Oyster Creek License Renewal Commitments Inspection Exit Meeting - Dec 3, 2008

Exec Summary of Inspection Results

(1) Commitment 27, ASME Section XI, Subsection IWE, Item (2) [(b)(5)] Ex 5

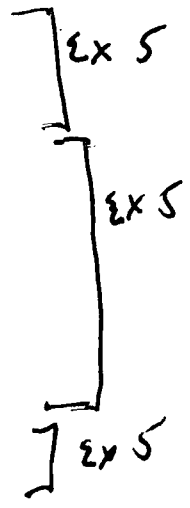
A strippable coating will be applied to the reactor cavity liner to prevent water intrusion into the gap between the drywell shield wall and the drywell shell during periods when the reactor cavity is flooded.

- The strippable coating initially limited leakage into the cavity drain trough at < 1 gpm. On Nov 7, the leakage rate took a step change to 4 to 6.gpm. Water was subsequently identified in 4 sand bed bays.
- This was also a previous commitment made in response to Generic Letter 87-05
